7.2 Reactor Protection (Trip) System (RPS)—Instrumentation and Controls

The information in this section of the reference ABWR DCD, including all subsections, tables and figures, is incorporated by reference with the following departures and supplements.

STD DEP T1 2.3-1 (Table 7.2-1, 7.2-2, Figures 7.2-2, 7.2-6, 7.2-9, 7.2-10)

Figure 7.2-2 Reactor Protection System Equipment Arrangement (From Sensors Through Trip Actuators)

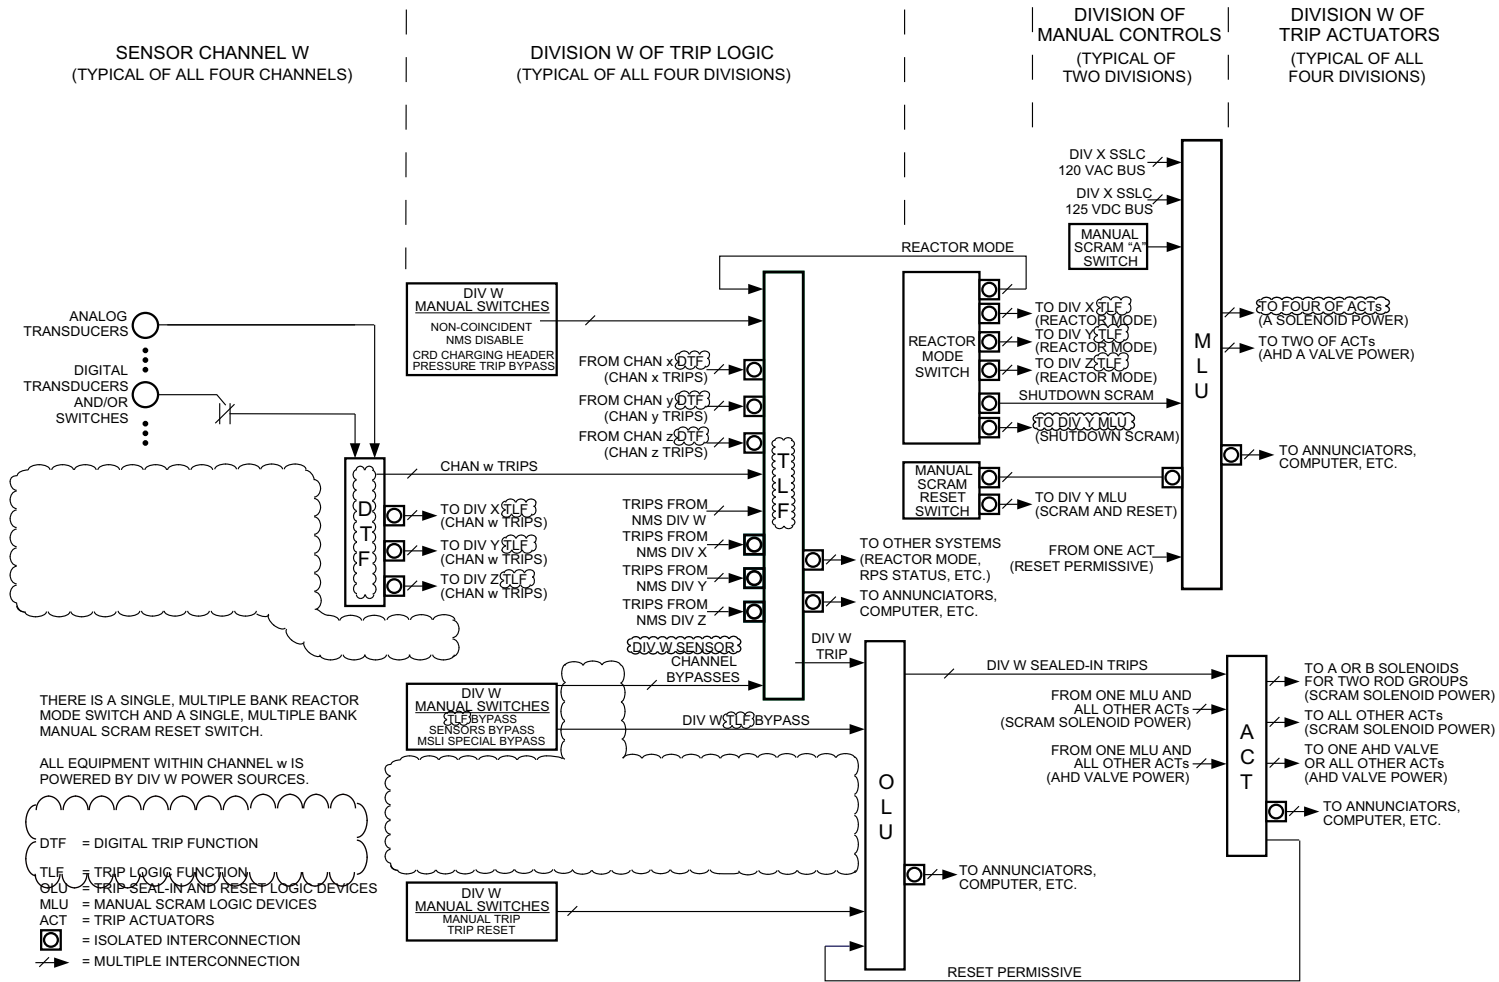
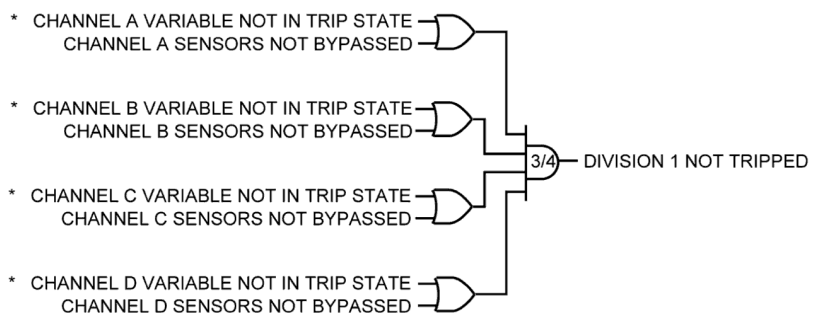
STD DEP T1 3.4-1 (Figures 7.2-2, 7.2-9, 7.2-10)

The RPS equipment is divided into four redundant divisions of sensor (instrument) channels, trip logics and trip actuators, and two divisions of manual scram controls and scram logic circuitry. The sensor channels, divisions of trip logics, divisions of trip actuators and associated portions of the divisions of scram logic circuitry together constitute the RPS scram and air header dump (backup scram) automatic initiation logic. The divisions of manual scram controls and associated portions of the divisions of scram logic circuitry together constitute the RPS scram and air header dump manual initiation logic. The automatic and manual scram initiation logics are independent of each other. RPS equipment arrangement is shown in Figure 7.2-2.

Equipment within a sensor channel includes primarily sensors (transducers or switches), ~~multiplexers and digital trip modules (DTMs)~~ trip functions (DTFs). The sensors within each channel monitor plant variables (Subsection 7.2.1.1.4.2) ~~and send either analog or discrete output to remote multiplexer units (RMUs) within the associated division of Essential Multiplexing System (EMS) the DTF.~~ Each division of the EMS performs analog to digital conversion on analog signals and sends the digital or digitized analog output values of all monitored variables to the DTM within the associated RPS sensor channel. The ~~DTM DTF~~ in each sensor channel compares individual monitored variable values with trip setpoint values and for each variable sends a separate, discrete (trip/no trip) output signal to all four divisions of trip logics.

Four independent sensor channels monitor the various process variables listed in Subsection 7.2.1.1.4.2. The redundant sensor devices are separated so that no single failure can prevent a scram. The arrangement of RPS sensors mounted in local racks is shown in Figure 7.2-2. Locations for local RPS racks and panels are shown on the instrument location drawings provided in Section 1.7. ~~Divisional separation is also applied to the Essential Multiplexing System (EMS) D which provides data highways for the sensor input to the logic units. Physically separated cabinets are provided for the four scram logics. Fiber optic cable routing from remote multiplexing units (RMUs) remote digital logic controllers to control room equipment is shown in raceway plans provided by reference in Section 1.7.~~ The criteria for separation of sensing lines and sensors are discussed in Section 7.1.

Figure 7.2-6 Division 1 Trip Logic

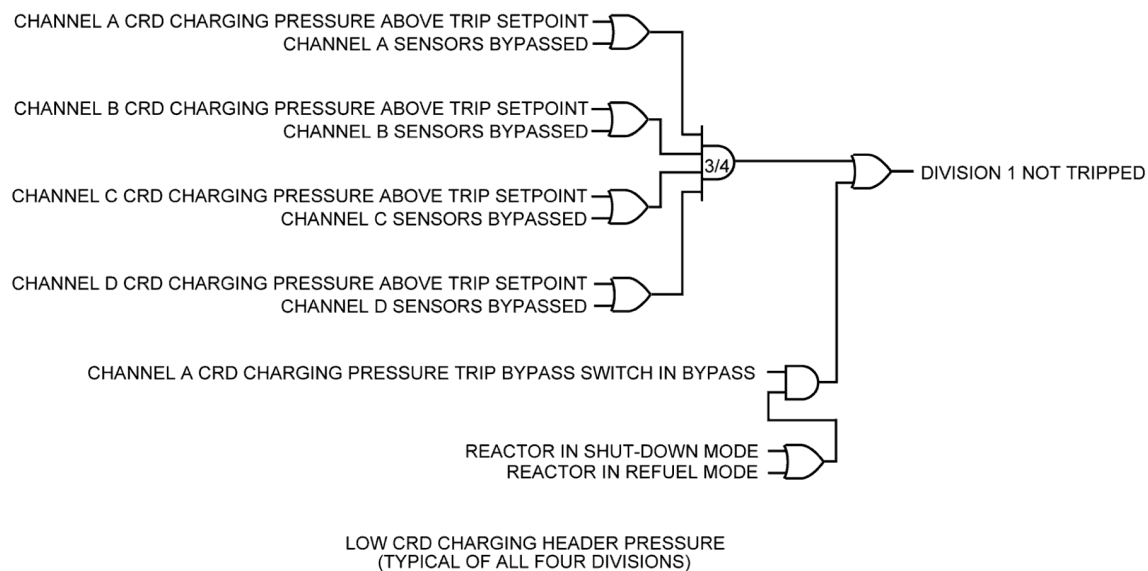
(2) Nuclear Boiler System (NBS) (Figure 7.2-6)

(3) Control Rod Drive (CRD) System (Figure 7.2-6)

(4) ~~Process Radiation Monitoring (PRM) System (Figure 7.2-6)~~ Not Used

~~High Main Steamline Radiation Trip (Figure 7.2-6)~~

~~A high main steamline radiation trip will occur in each division of trip logic when a main steamline radiation trip condition exists in any two or more unbypassed sensor channels. There are no operating bypasses associated with this trip function.~~
